# STAFF CASE REPORT TO PLANNING COMMISSION

<b>Subdivision Name:</b>		<b>A.A. Bowmans Subdivision Lots 3, 4, and 5 Variance Request-Minimum Suburban Infill Lot Frontage</b>	<b>PC Meeting Date: 07-14-14</b>
<b>Applicant Request:</b>	Variance-Section 38-44 of the Chattanooga Zoning Regulations (7) Minimum Suburban Infill Lot Frontage		
<b>Property Location:</b>	8307 Igou Gap Road		
<b>Property Owner:</b>	Sterling Jetton		
<b>Applicant:</b>	MAP Engineers		
<b>Total Acreage:</b>	3.02 Acres		
<b>Proposed Density:</b>	1.65 dwelling units per acre		
<b>Tax Map Number:</b>	159F-B-023		
<b>Zoning:</b>	R-1 Residential Zone		
<b>Staff Recommendation:</b>	<b>DENY</b>

# A.A. Bowmans Variance Request

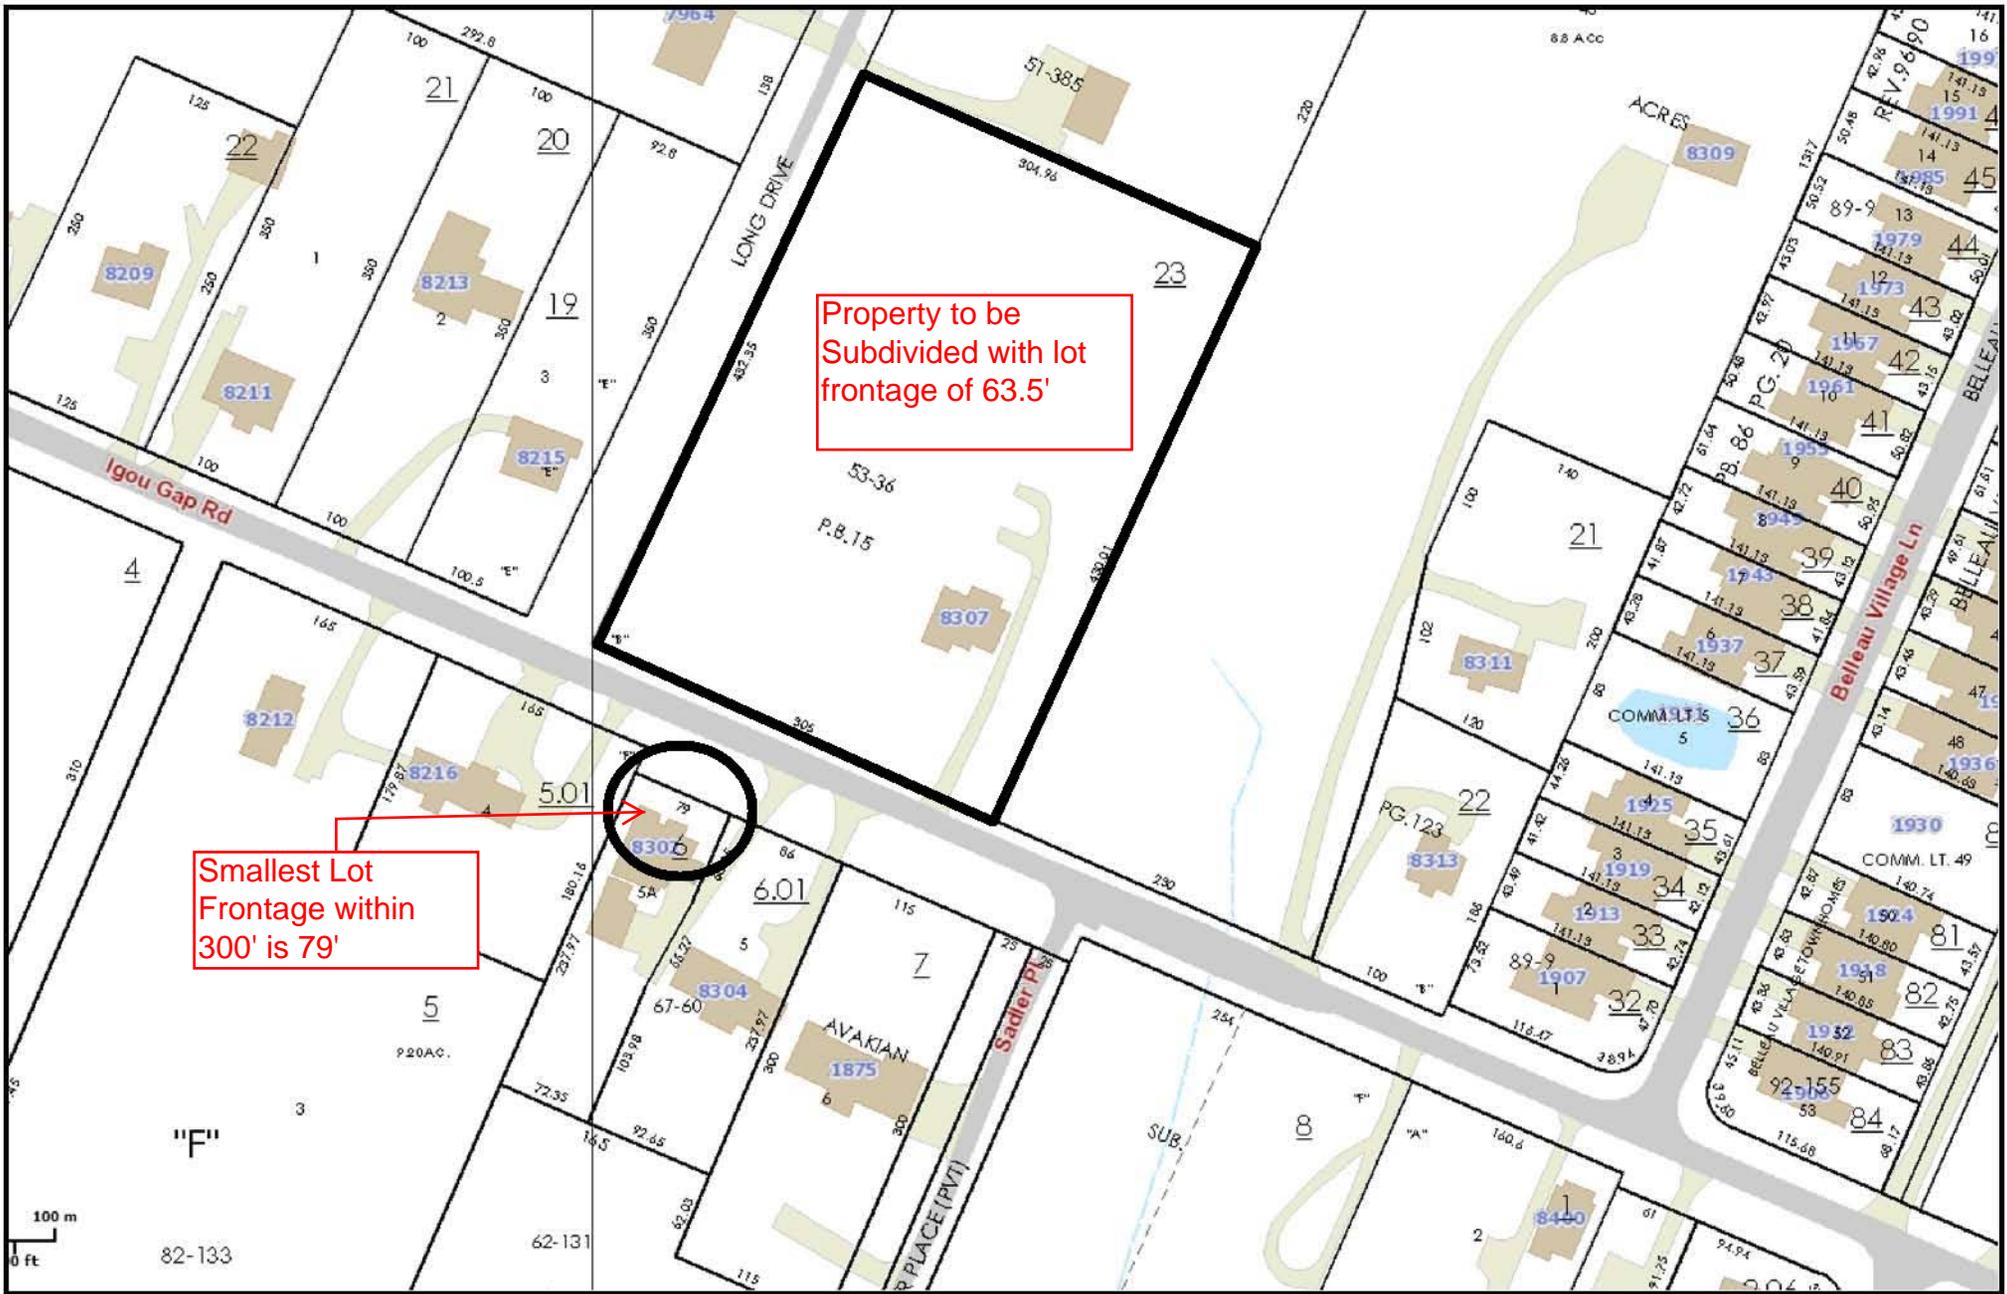
The applicant is requesting a variance to permit proposed Lots 3 thru 5 to have a lot frontage along Igou Gap Road that is less than the required minimum of 79'. The proposed lot frontage for these lots is approximately 63.5'; therefore, the applicant is seeking a reduction in the required minimum lot frontage of approximately 15'.

2. The Chattanooga-Hamilton County Regional Planning Commission approved the variance request.
3. Based on Hamilton County GIS, the total lot frontage along Igou Gap is approximately 305. The applicant intends to keep the existing house on a separate lot (Lot 6). Taking out the lot frontage of Lot 6, which is 114.47' the applicant will have approximately 200.7'. Using the minimum required lot frontage of 79' the applicant appears to have enough lot frontage to create two additional lots along Igou Gap rather than the proposed three additional lots.

4. There does not appear to be any unusual or physical condition present that would cause impractical difficulty or hardship with complying with the minimum lot frontage of 79'. The developer desires three additional lots, if the lot frontage is complied with then it appears only two lots will be created.

5. Approving the variance will be in conflict with the intent and purpose of these regulations. The intent of the Suburban Infill Lot Frontage is to create lots that are compatible with adjoining lots. The lot frontages of existing lots on either side of the property being subdivided are 100' and 230'. Excluding the existing flag lots, the lot frontage across the street range in size from 79', 86', 115' and 165'.

6. Granting the variance would set the precedent for future requests along Igou Gap Road. Permitting minimum lot frontages of 63' would create lots that would not be compatible with the adjoining lots, which would be in conflict with the intent and purpose of this regulation.

Any potential subdivision of the property must include discussions concerning proposed Lot 7. As it stands today, Lot 7 does not have lot frontage along an existing public road built. Before a subdivision plat can be approved for this site discussions need to occur between the developer and Transportation Department concerning required improvements within the right-of-way of Long Drive.

Staff recommends to deny the applicant's request for the variance.
